Plans versus Observed Construction

These photographs are directly related to the same section of this report identified above.

2078 Plans versus Observed Construction

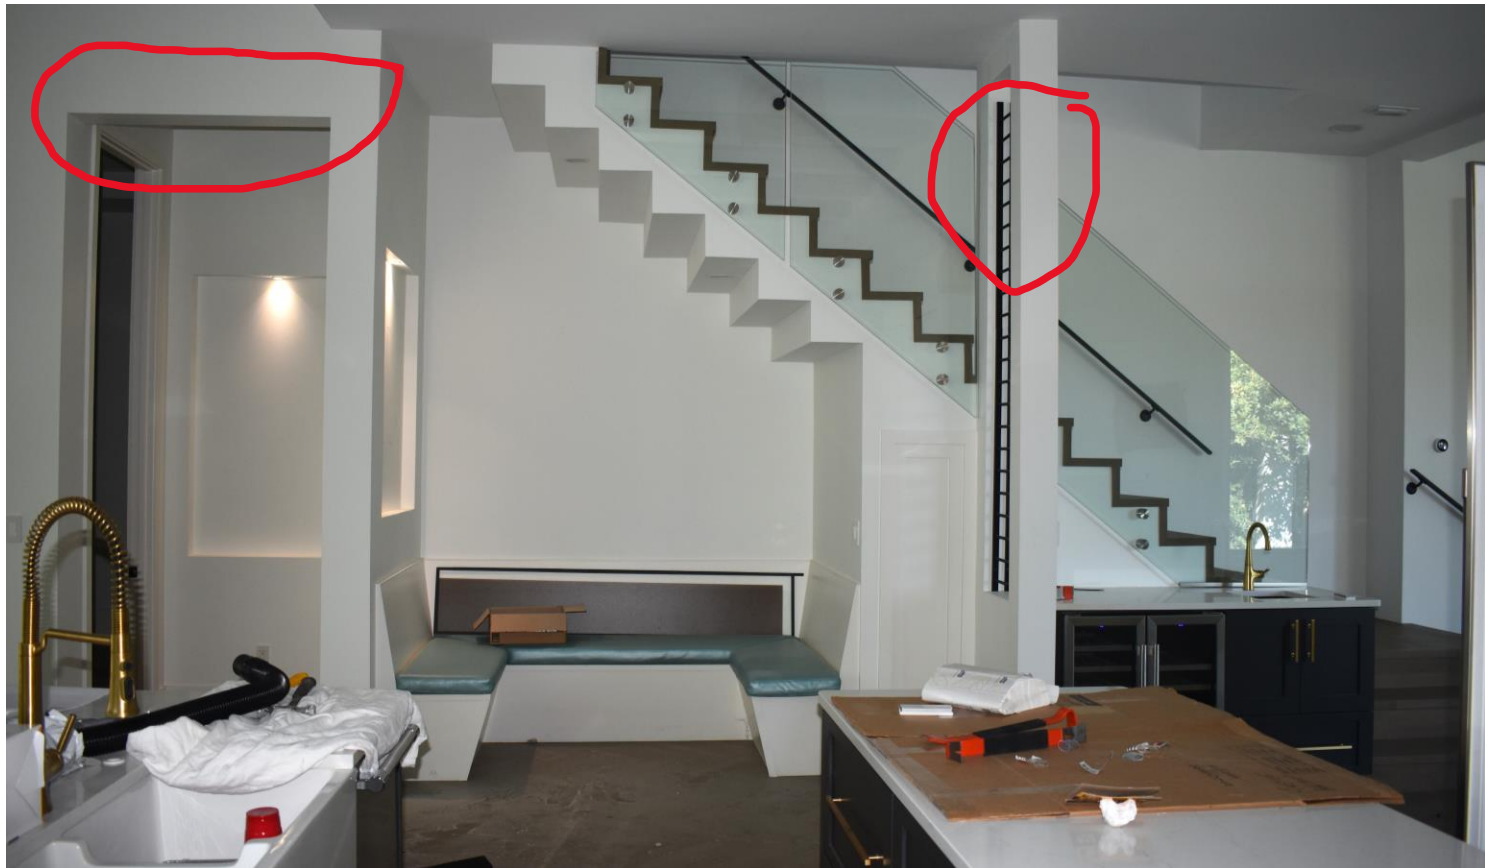
The wall pictured from left to right is load bearing and shall contain areas where multiple King studs are used, The bedroom egress wall, the short-wet bar wall are also load bearing. Three pre-engineered laminated columns are also designated for use. At least two laminated posts designed for 3100 SP are missing.

City of Winter Park Building Inspectors failed to enforce Drawings/Engineering
